# Memorandum

To	Eugene White - Mulpha	Date	9 February 2018
Copies	Grant Bambach - Savilles George Cunha - Arup Glen Scott - Hassell	Reference number	252120
From	Peter Jameson - Arup	File reference	Memo_1_Existing_Rev3
Subject	Memo 1: Transport House – Additional Existing Building Assessment_Rev3

Please find below updated comments with respect to our assessment of the proposed ballroom extension the Transport House.

SCALE - 1/8 INCH TO ONE FOOT.  
 + MEZZANINE FLOOR PLAN +

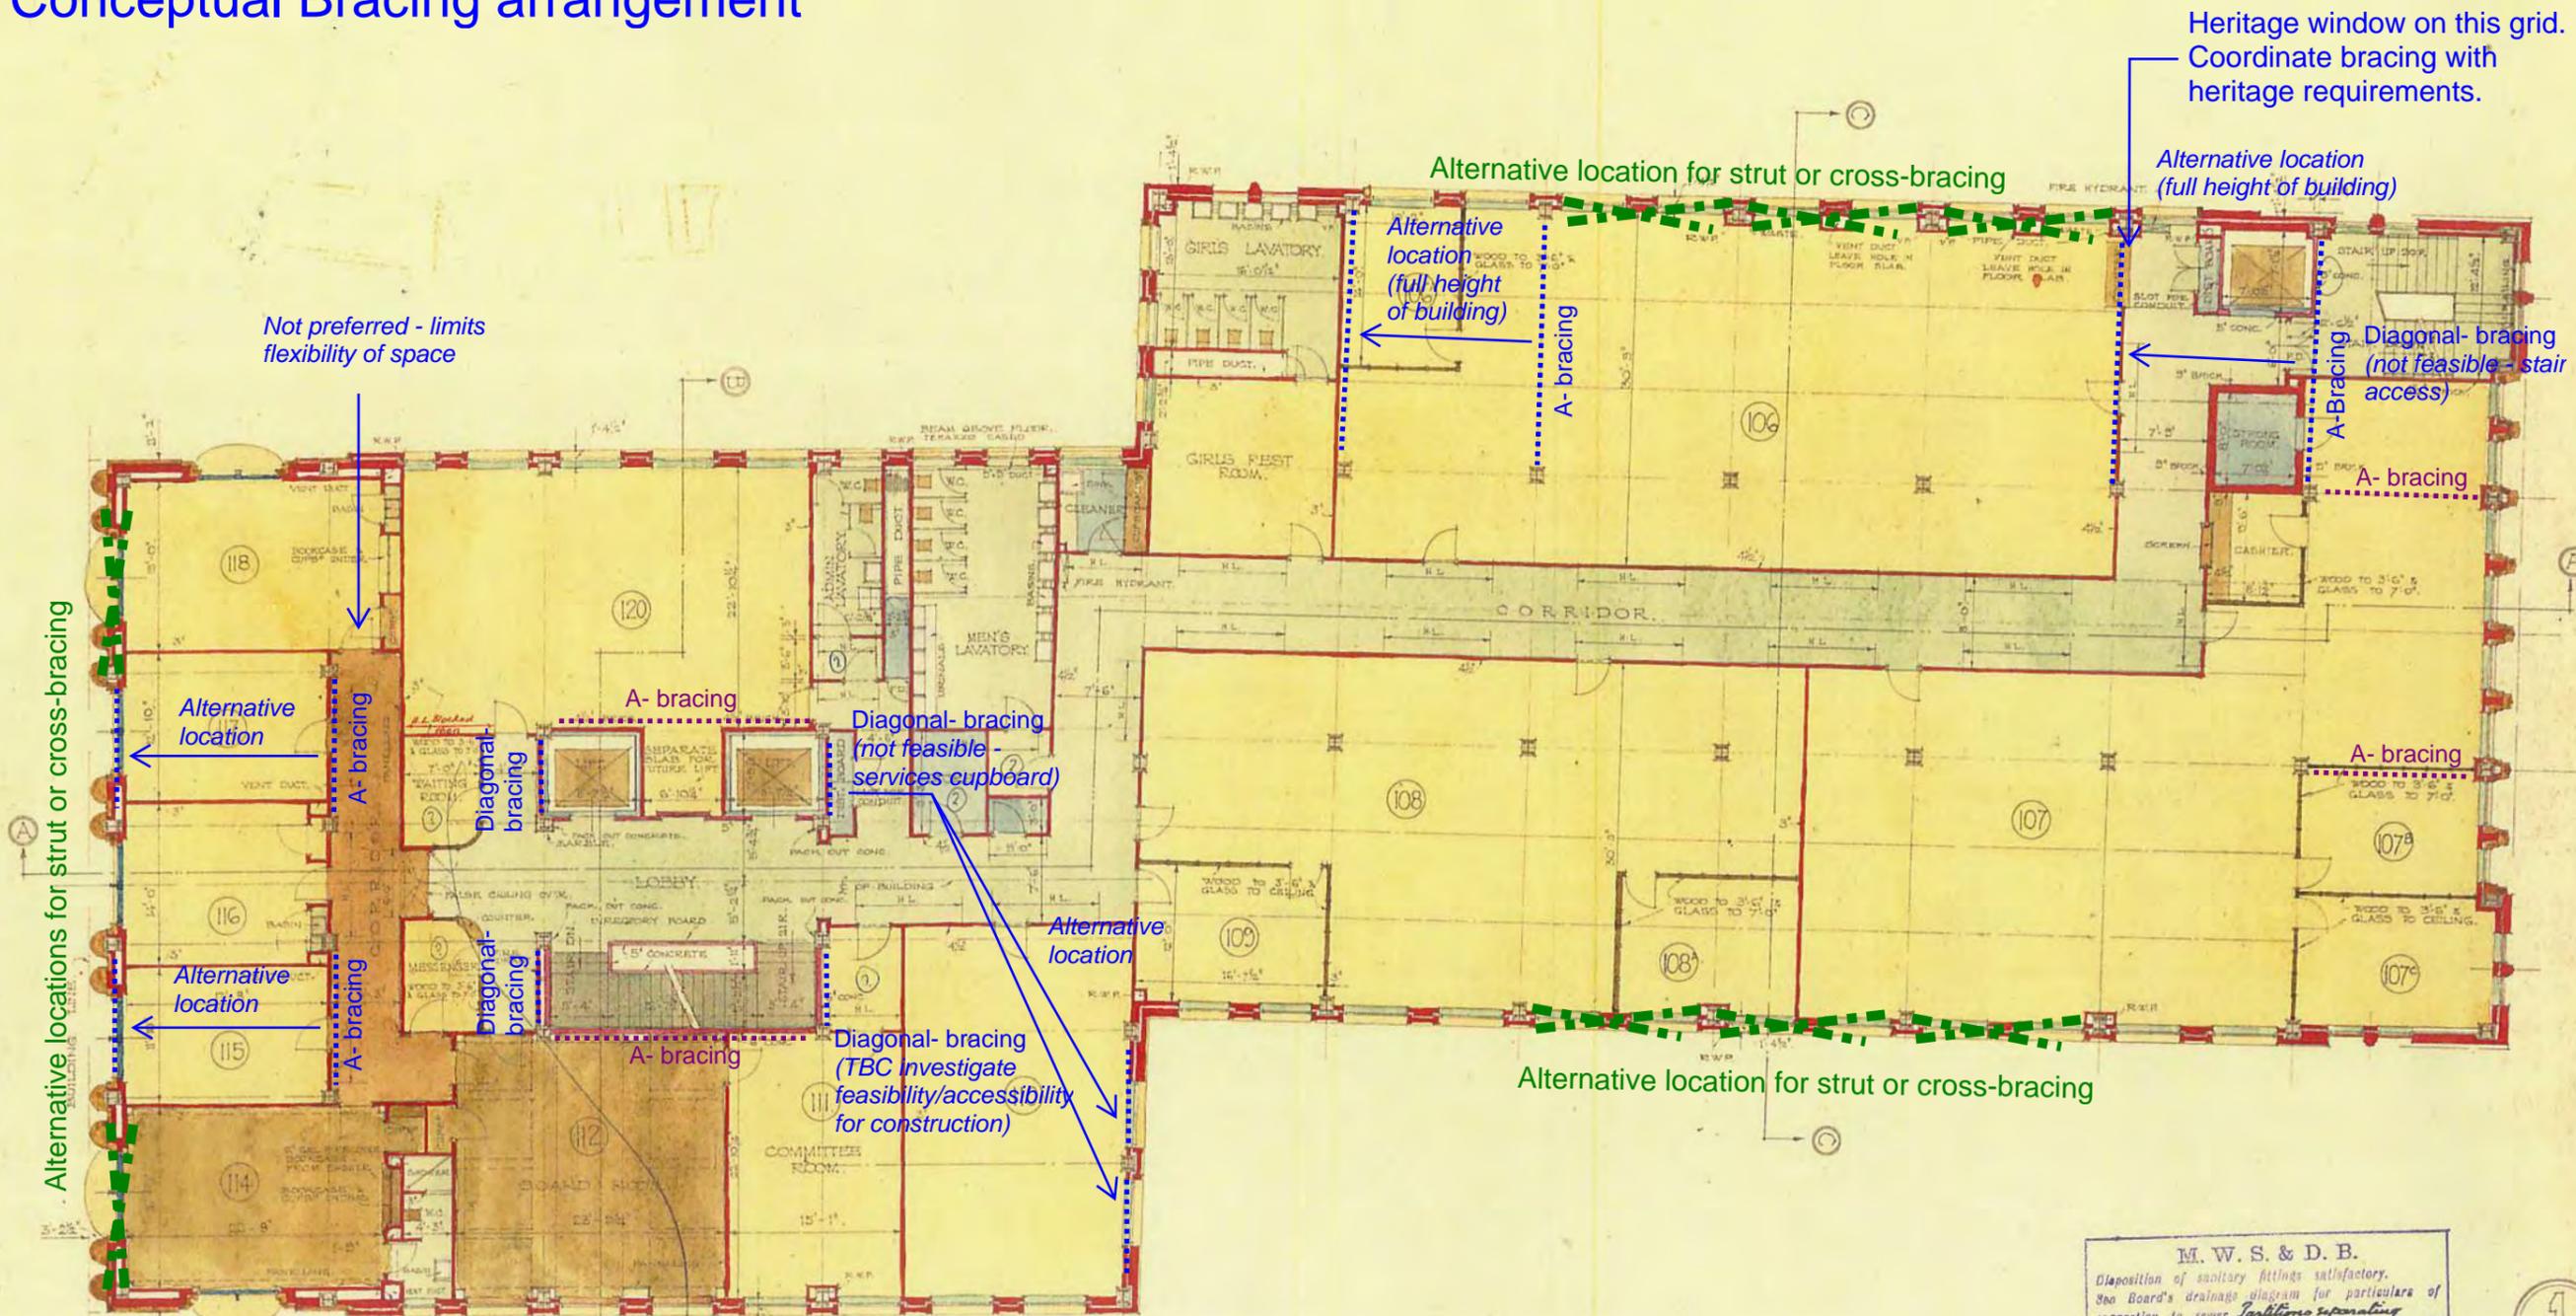
Heritage window on this grid.  
 Coordinate bracing with heritage requirements.

Alternative location (full height of building)

Alternative location (full height of building)

Diagonal-bracing (not feasible - stair access)

Not preferred - limits flexibility of space

Alternative locations for strut or cross-bracing

Alternative location

Alternative location

Diagonal-bracing (not feasible - services cupboard)

Alternative location

Diagonal-bracing (TBC investigate feasibility/accessibility for construction)

Alternative location for strut or cross-bracing

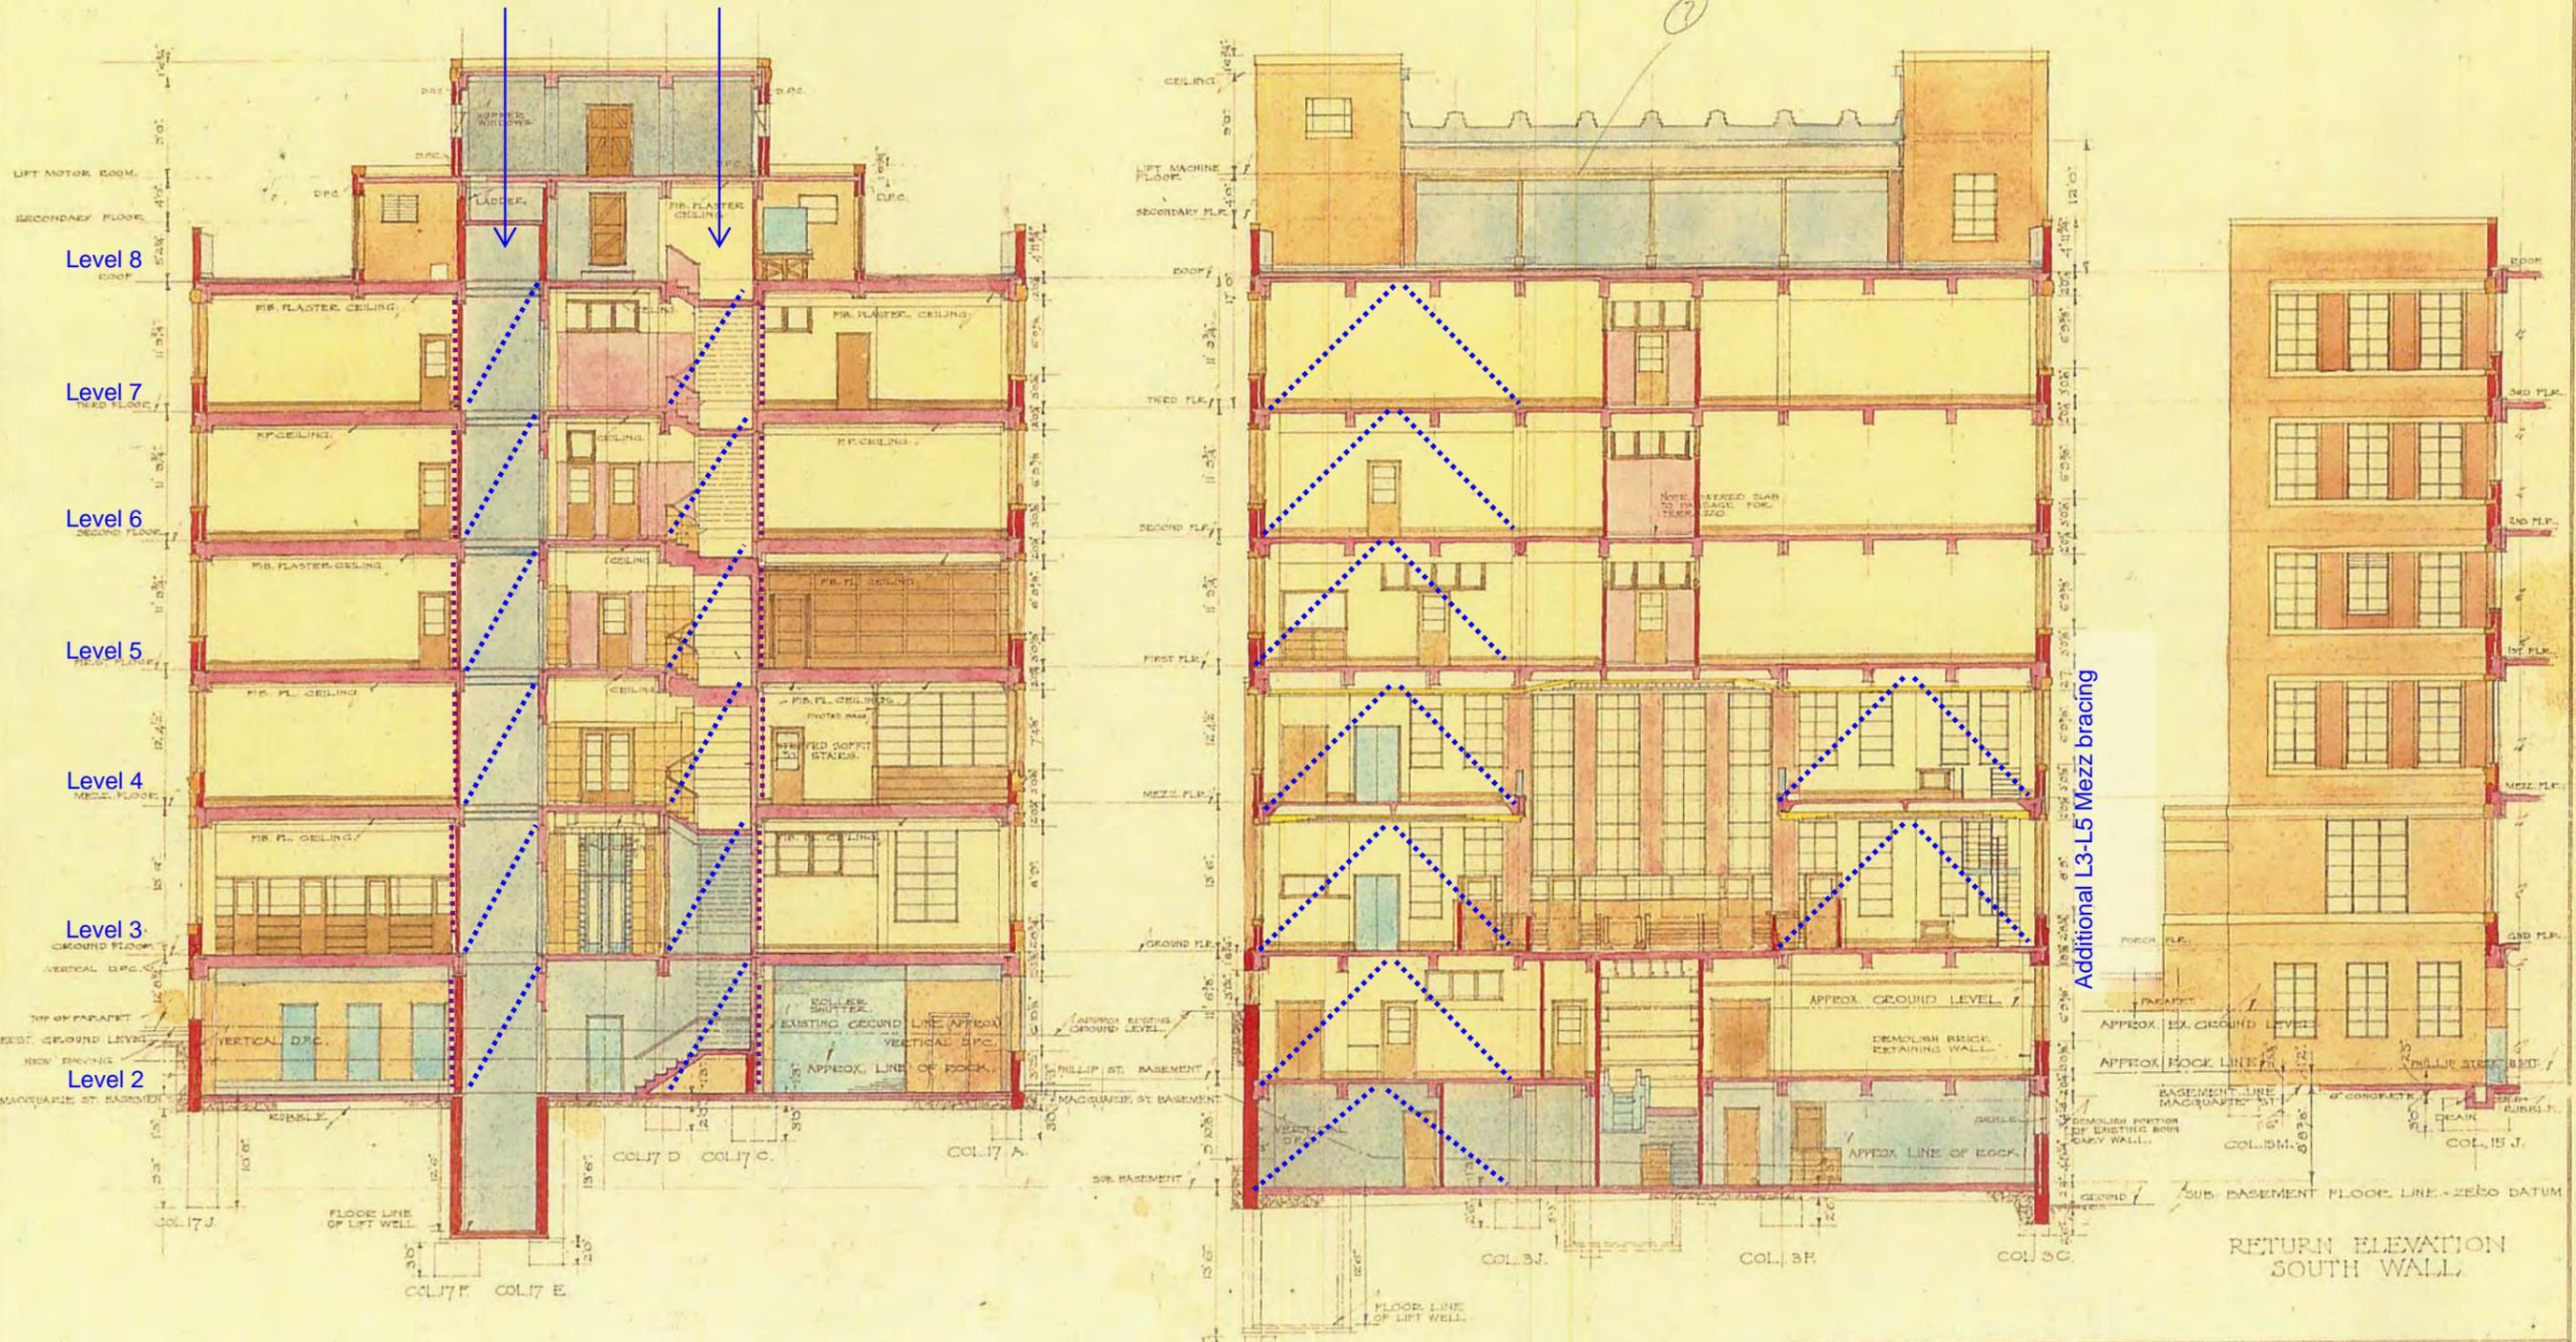
Diagonal-bracing  
South-West corner  
(not feasible -  
services cupboard)

Diagonal-bracing  
North-West corner  
(TBC investigate  
construction)

Additional L3-L5 Mezz bracing

Alternative bracing locations not show for clarity (refer plans)

ELEVATION TO MACQUARIE STREET.

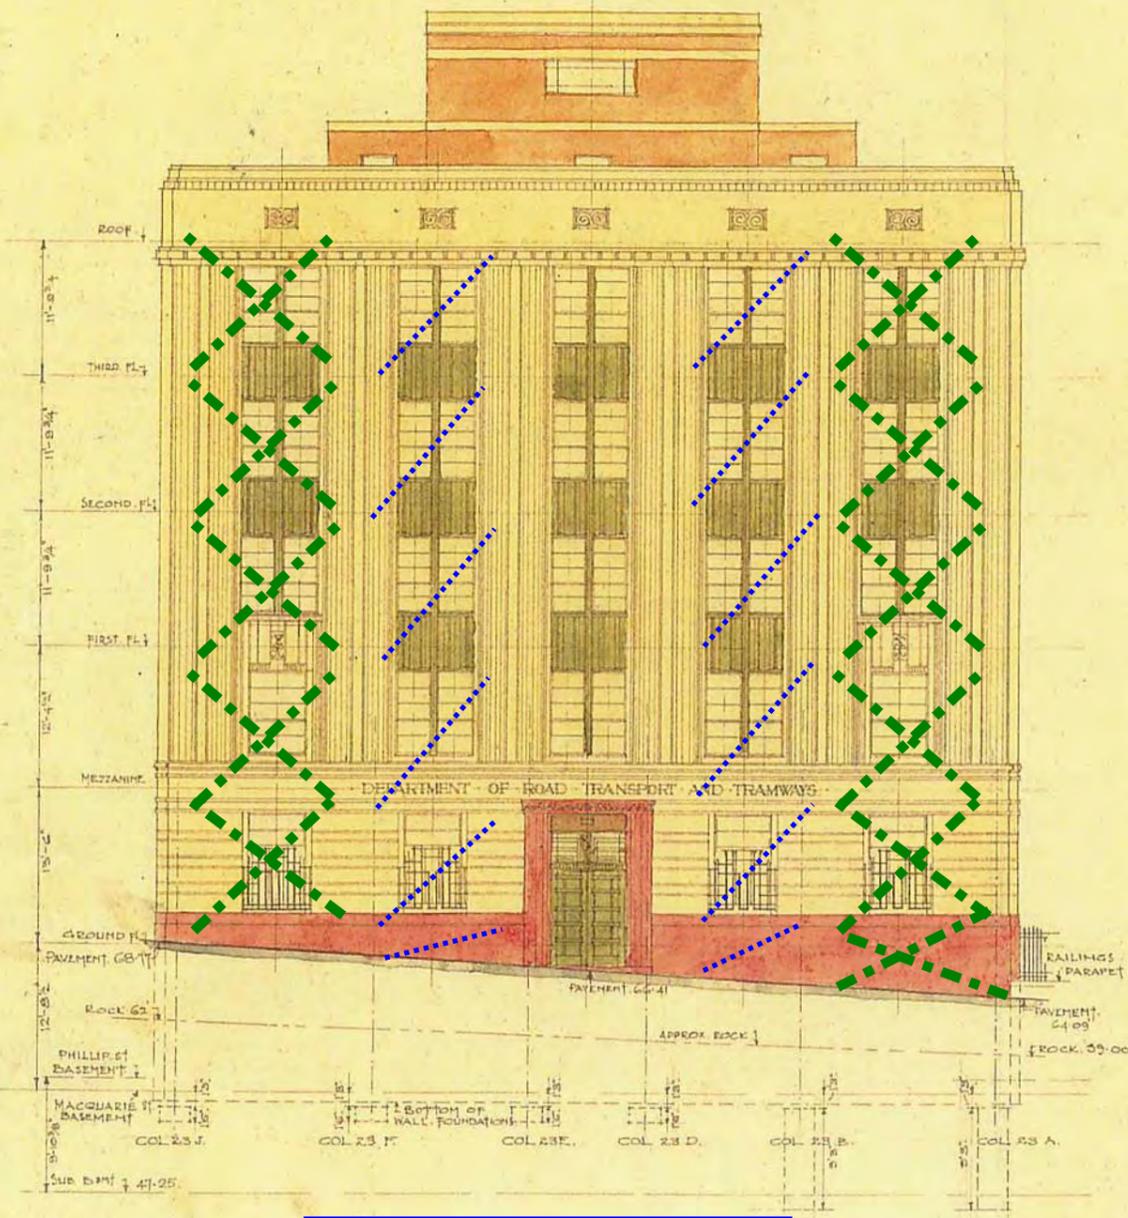
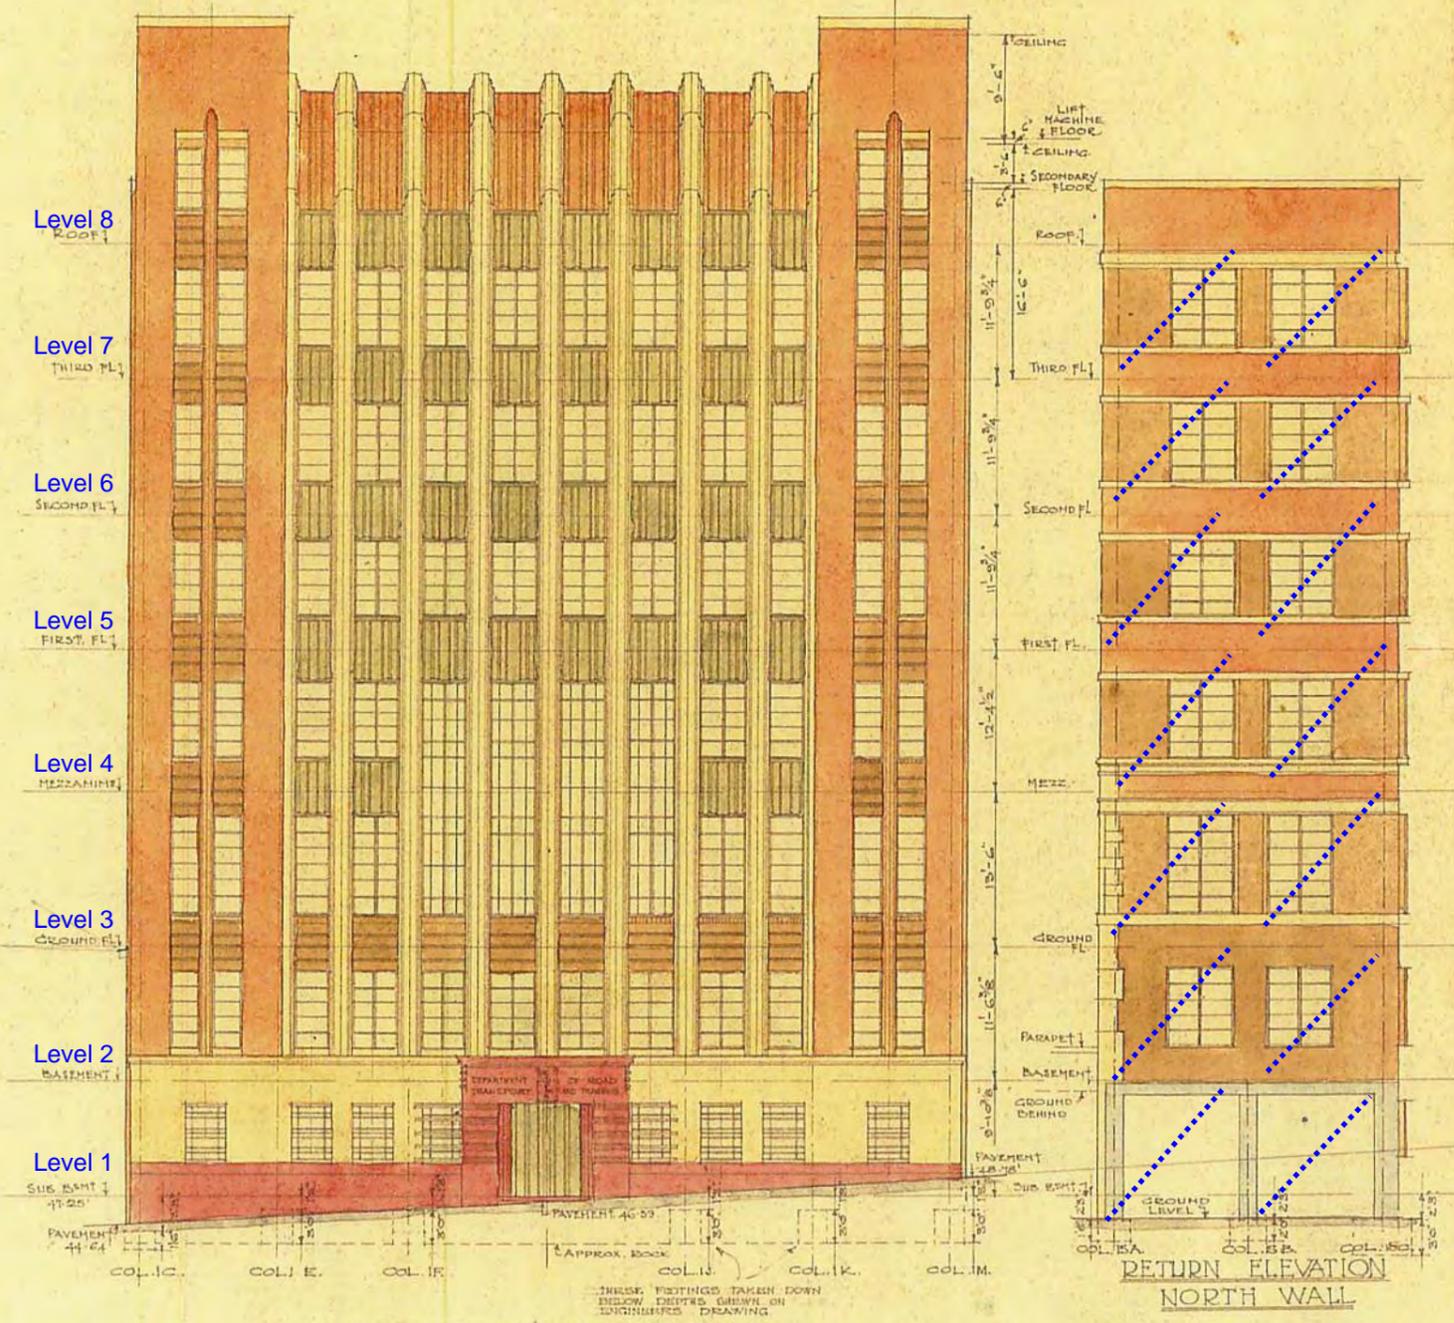
Alternative bracing location  
 behind facade (refer plans)

Alternative locations for strut or cross-bracing

Alternative bracing location  
 behind facade (refer plans)
